APPLICATION
FOR PERCOLATION TESTING AND SITE EVALUATION

Re: Currier Property
16750 AE Mullinix Road
Percolation Certification Plan

RE: Currier Property
16750 A E Mullinix Rd
Woodbine, MD 21797

After review of the percolation certification test plan here are my comments.

16750 A. E. Mullinix Rd.

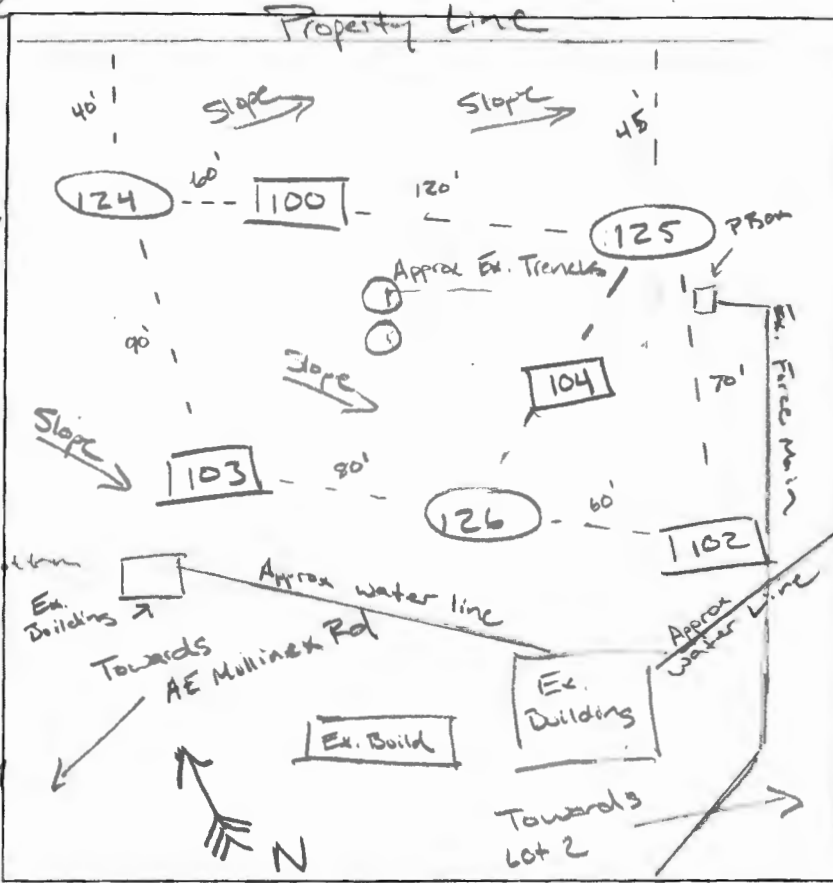
DATE	TEST #	DEPTH	START	BREAK 1' DROP	STOP 2' DROP	TIME OF 2nd INCH	P/F/H
4/13/2023	126	4 / 13	10:51	11:15	SLOW	W	F
	125	5 / 12	9:53	10:00	10:09	9	P
	124	5 / 12	10:30	10:31	10:35	4	P
	127	7 / 14	11:42 ₃₀	11:45 ₃₀	11:43 ₄₆	FAST	F
	127	7 / RP	11:45 ₃₀	11:46 ₃₀	11:47 ₃₀	FAST	F

Ends of trench uncovered. Stone appears to be in good condition. Cleanouts installed at ends of trenches. OSDS good for 3 Bedrooms.

REMARKS: [Symbol] = Percs from 2/9/2023, SDA relatively flat area

(127) + (128) proposed on Lot 2, O = Trench Observation / cleanout installed
